Northern Pathology Development NMA Application

This document accompanies an application for a non-material amendment to the approved development at the Northern Pathology Department, The Christie Hospital, Manchester, 143740/FO/2025.

Proposed Amendment A: External works layby including addition of the generator

Proposed Amendment B: Louvre setting out

Amendment Plan

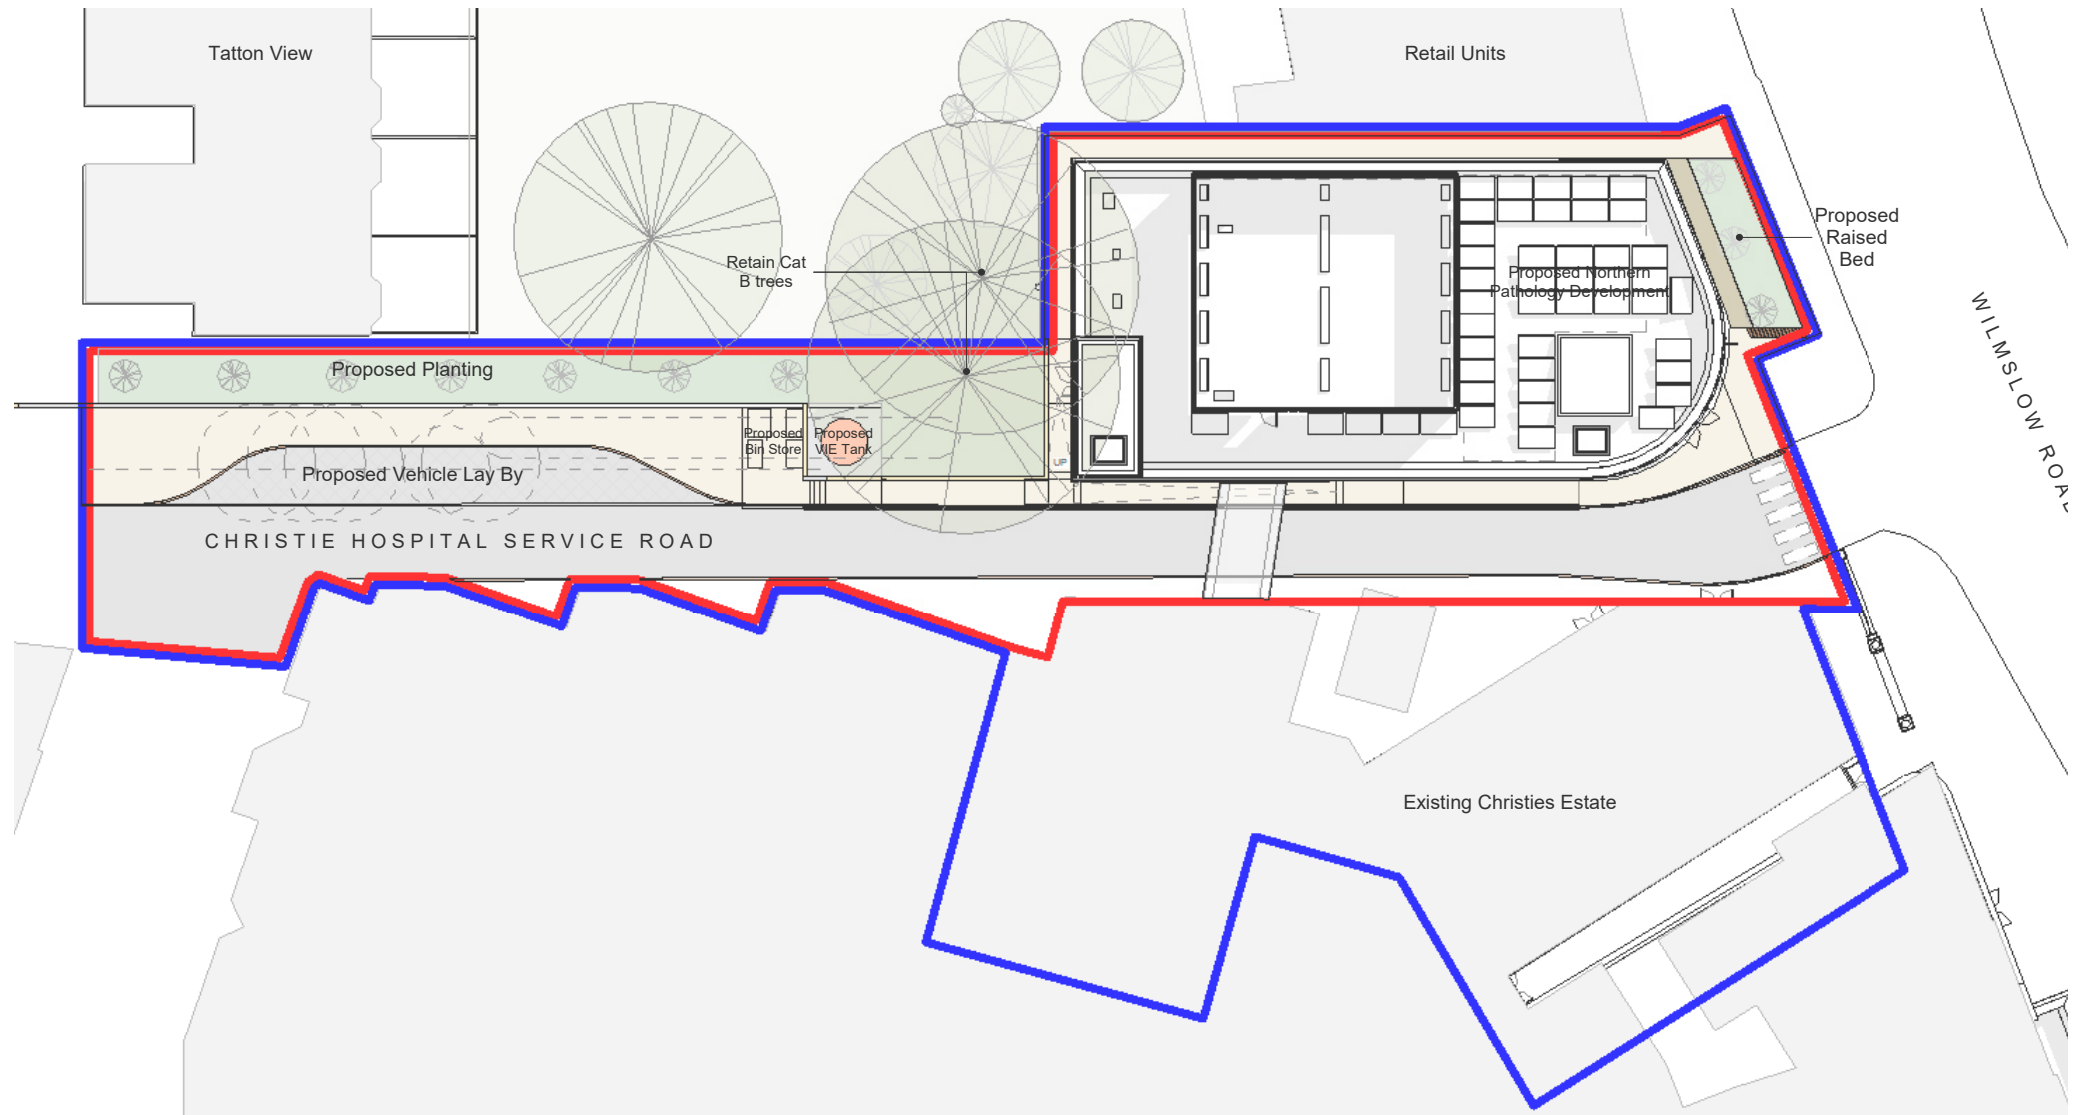
1 – Layby and bin store location

One of the principal challenges encountered with the external works has been avoiding the tree root protection zones. As the design was developed in greater detail, it became apparent that the slab for the bin store and tank would need to be relocated further west to avoid them. This adjustment has resulted in a reduction in the size of the layby; however, this is not anticipated to cause any issues, as the original layby provision was extended from the required 12m dimension to accommodate a turning circle from the service yard. With the new arrangement, the layby meets the original 12m required and still accommodates the turning circle.

2 – Omission of the nitrogen tank, replacing with a generator

As part of wider Hospital campus works a decision was taken by the Christie Hospital Trust to relocate the nitrogen tank directly to the opposite side of the road, adjacent to the existing hospital buildings. During the subsequent design development, additional requirements relating to power supply provision were identified. In particular, the proposed pathology building requires both essential and non-essential power supplies. The Trust's Facilities Management team has confirmed that the existing hospital electrical infrastructure does not have sufficient capacity to provide the required essential power supply to the new building. As a result, the provision of a dedicated standby generator is necessary to support the development.

Following a series of design reviews involving the project team, specialist consultants and the Trust, it was concluded that the only feasible solution is for the generator system to be located externally. Given the spatial constraints of the site, the generator has been designed to be as compact as practicable. As illustrated in the submitted sections, the generator will be effectively screened from surrounding residential viewpoints and will be significantly less visually prominent than the nitrogen tank previously included under the approved

A low-noise acoustically packaged generator selection is proposed to reduce noise at source as far as practically possible. This includes a proprietary acoustic enclosure and silencers to control noise emissions. An assessment of noise egress from the proposed generator to nearby noise sensitive premises has been carried out. The predicted noise egress levels meet with the emergency/stand-by plant noise criteria (as per Planning noise report dated 24 July 2025) during the day. It is not expected to be feasible to meet the emergency/stand-by criterion at night despite all reasonable noise mitigation measures, such as unit selection, location and screening having been considered. It is proposed that any routine testing be limited to be during the day only to reduce the risk of noise impact on the nearby residents.

3 – Addition of a fence

A fence has been introduced along the interface between the landscaped area adjacent to the layby and the neighbouring residential gardens. This will clearly define the site boundary and safeguard residential amenity by providing effective visual screening for adjacent properties. In addition, the fence will contribute to the mitigation of noise impacts arising from the service road and generator, thereby reducing potential effects on nearby dwellings.

4 – Additional green space

Following the amendment to the layby arrangement, an opportunity was identified to incorporate additional landscaped green space, as illustrated on the proposed site plan. This additional planting will enhance visual amenity within the site and increase the soft landscaping provision.

Design Amendments

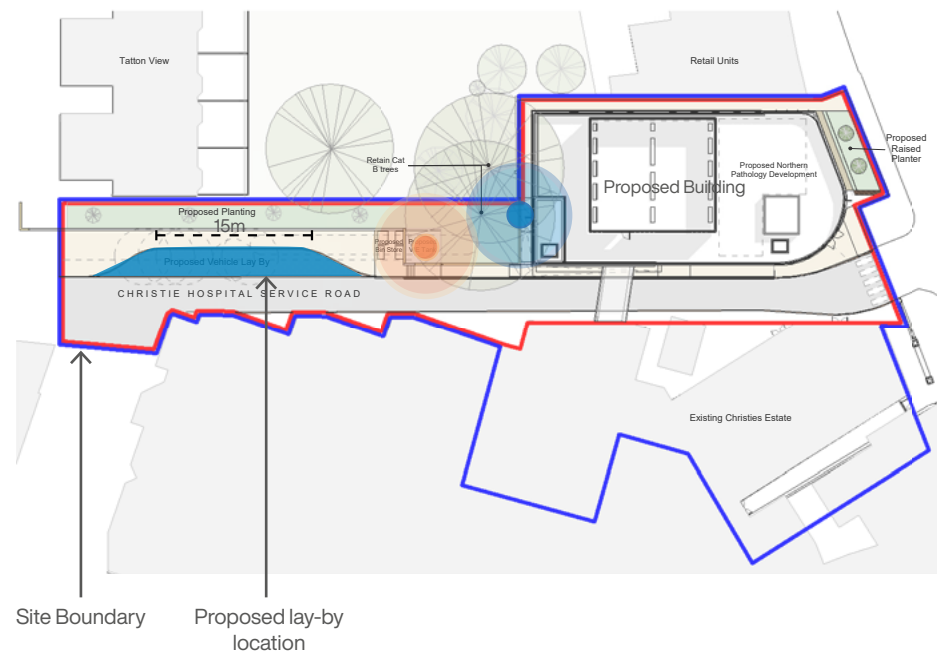
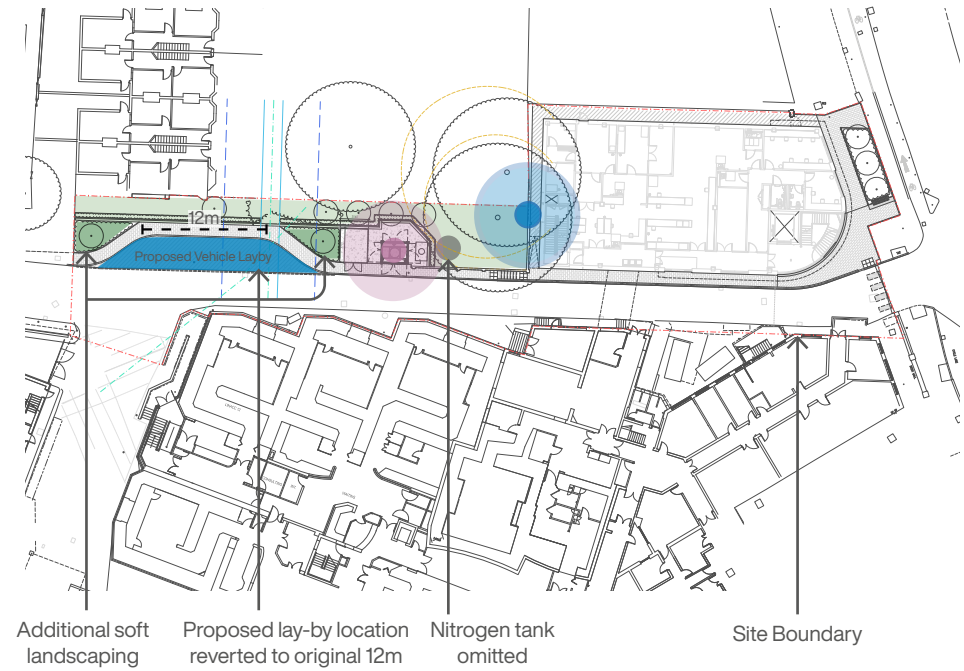
Approved External Works

Proposed External Works

Tank Location

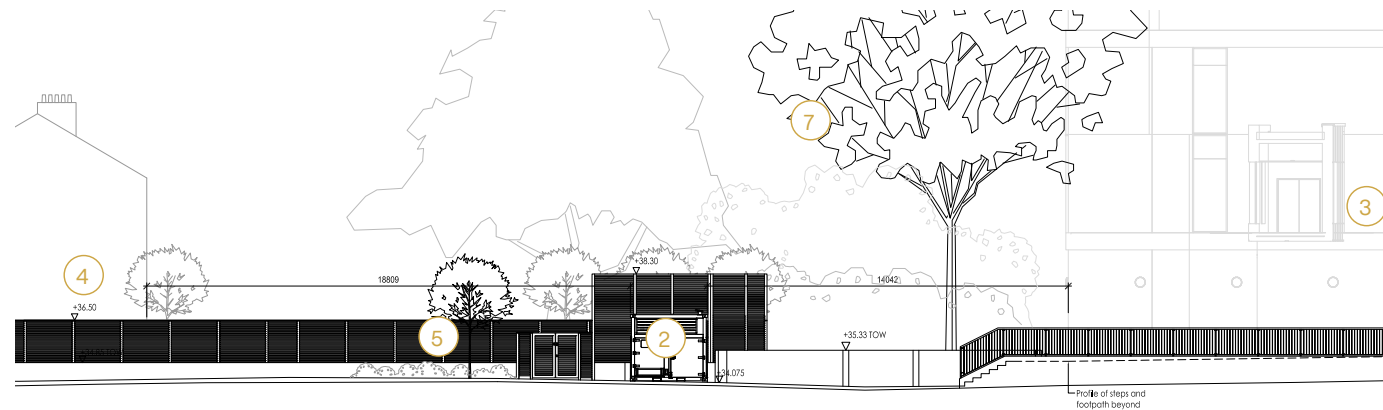
- ① Approved tank location
- ② Proposed generator location
- ③ Proposed building
- ④ Adjacent housing
- ⑤ Proposed planting barrier
- ⑥ Minimum distance for tank from residential buildings (3m)
- ⑦ Retained trees to provide visual screening

Proposed Tank Location

Proposed Generator Location

Proposed External Works - Generator Section

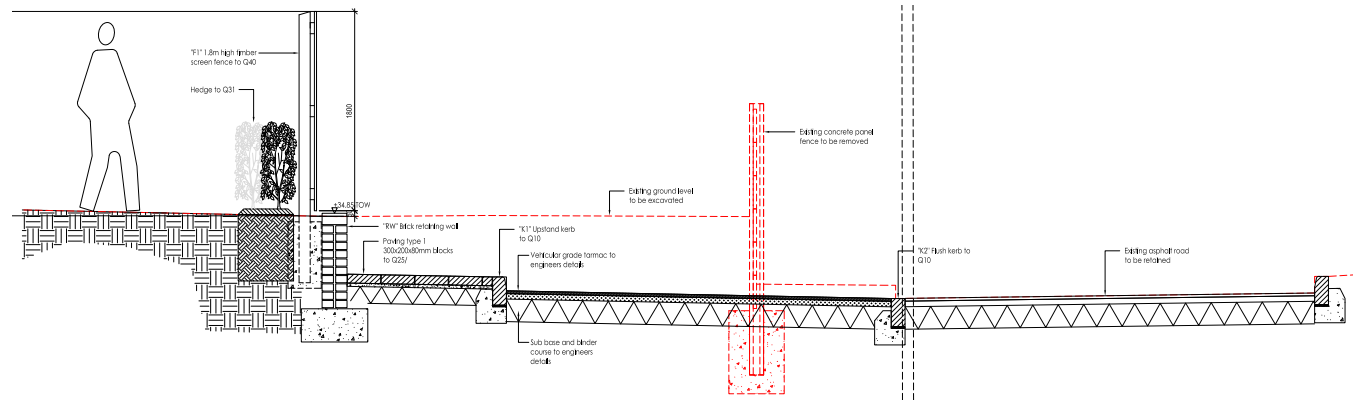
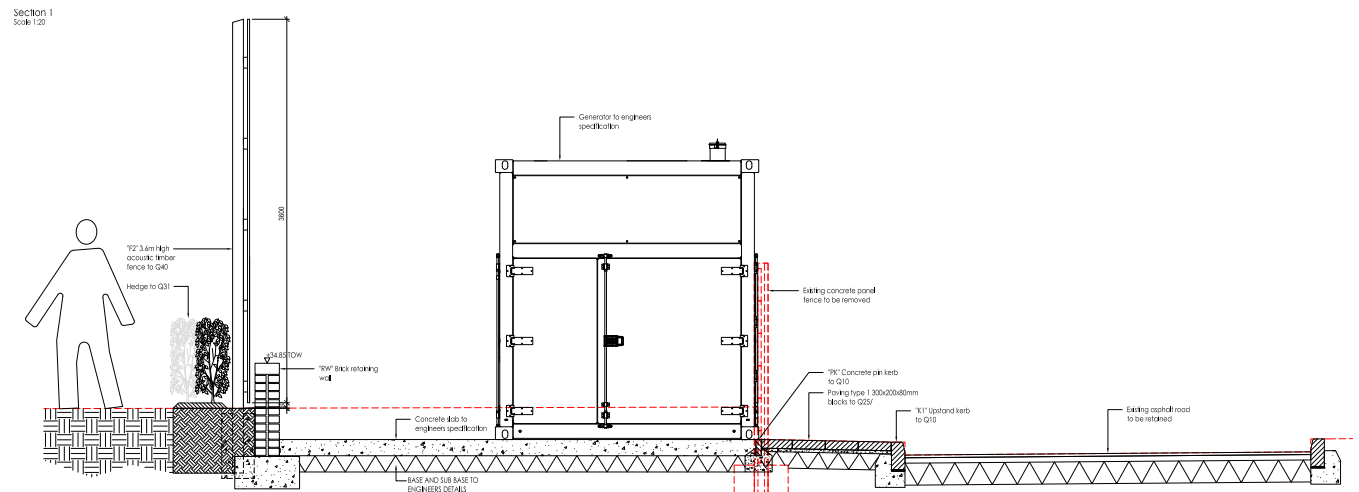
Section 1 - Raised Bed to LayBy (Including Proposed Fence)

Section 2 - Raised Bed to Generator (Including Proposed Fence)

Amendment Plan

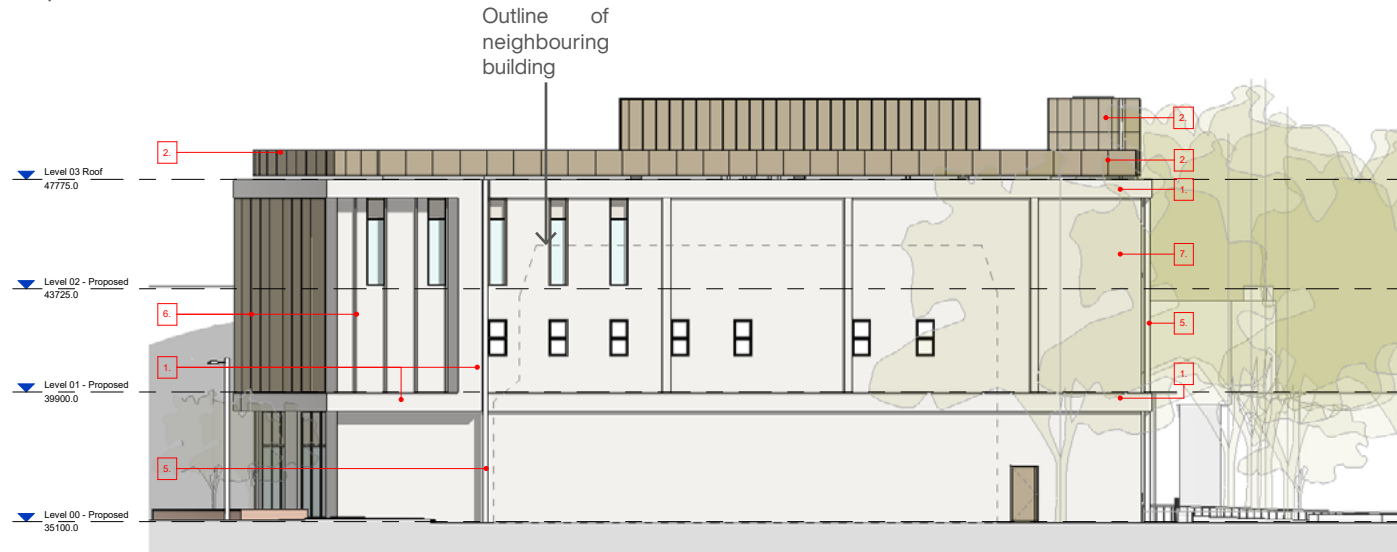
The approved elevations currently show two louvres on the west elevation. However, following further detailed design development, it became evident that this arrangement did not fully satisfy the requirements of the relevant HTM guidance, the approved fire strategy, or the acoustic strategy.

In relation to HTM requirements, the guidance specifies maximum permissible air velocities through louvres. It was determined that compliance with these limits could not be achieved with only two louvres located on the west elevation.

With regard to fire safety, the building is subject to restrictions on the maximum extent of unprotected area due to its proximity to adjacent buildings. Under the previously indicated arrangement, the size of the two west-facing louvres exceeded the allowable percentage of unprotected area. The introduction of two additional louvres on the north elevation enables the overall louvre area to be distributed more evenly, allowing each opening to be reduced in size and brought into compliance with the unprotected area limits set out in the fire strategy.

From an acoustic perspective, reliance on only two louvres would necessitate increased air velocities, resulting in noise levels exceeding those permitted under the approved acoustic strategy. In addition, in-duct attenuators will be provided to ensure that the plant noise egress criteria are still achieved.

Distributing the louvres across both the west and north façades provides an optimal technical solution, allowing face velocities to remain within HTM limits, maintaining compliance with the acoustic strategy, and ensuring adherence to the fire safety requirements. This revised arrangement represents the most appropriate and balanced design approach, addressing all technical constraints while minimising potential impacts on neighbouring properties and preserving the visual character of the building.

Proposed Elevations

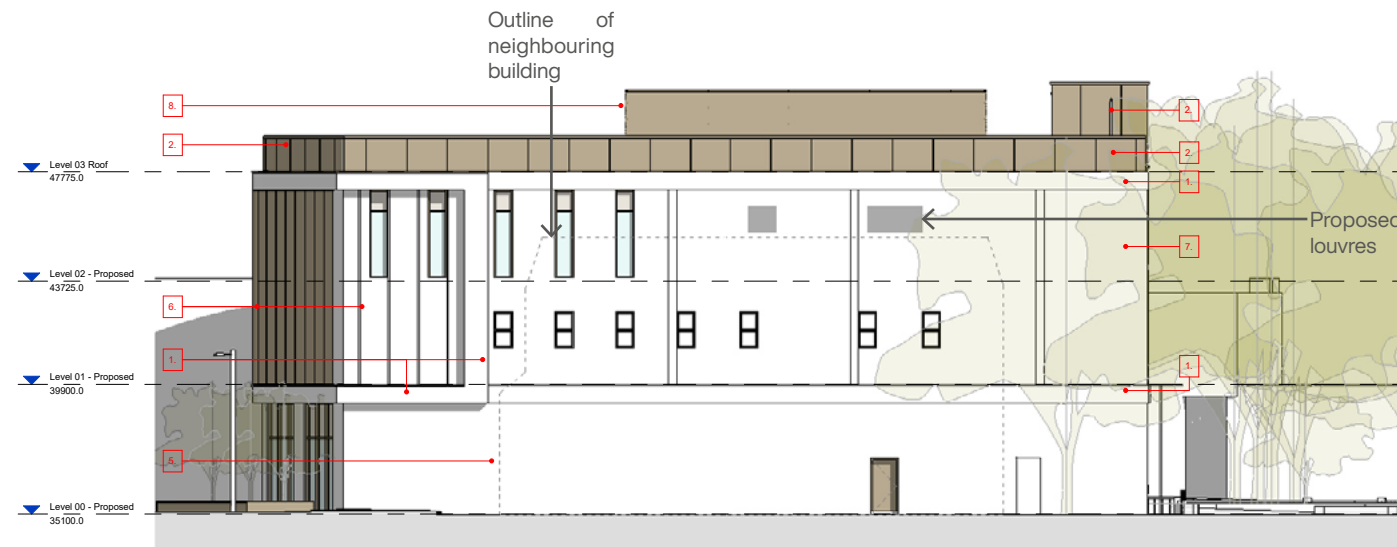
Approved North Elevation

Proposed North Elevation

Proposed Elevations

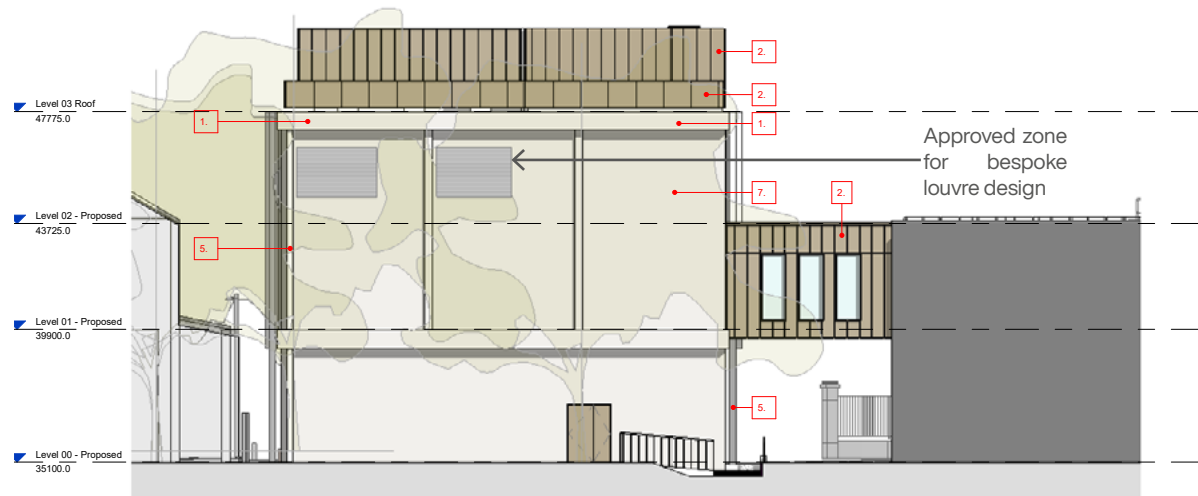
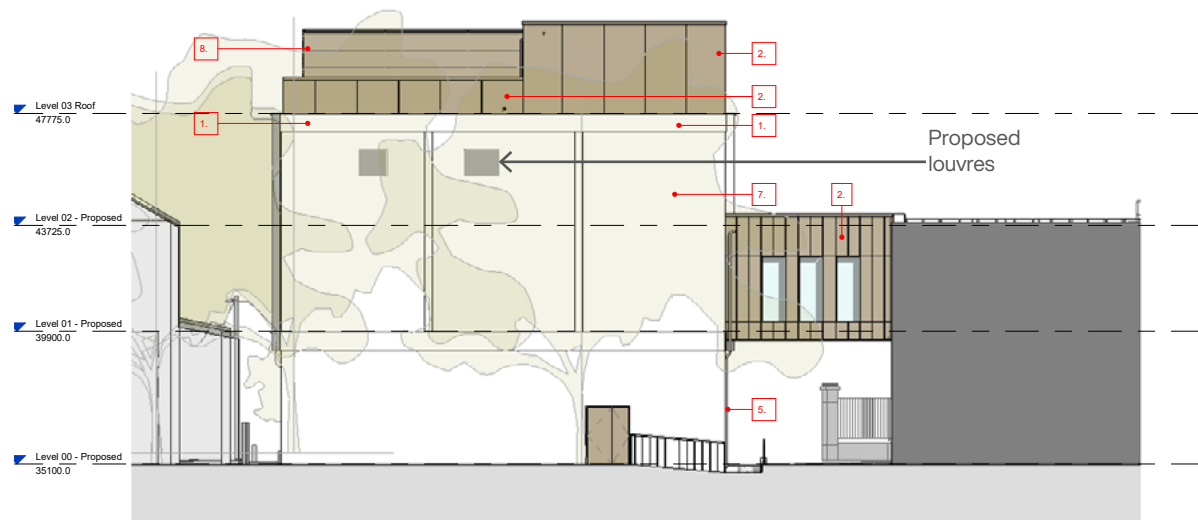
Approved West Elevation

Proposed West Elevation
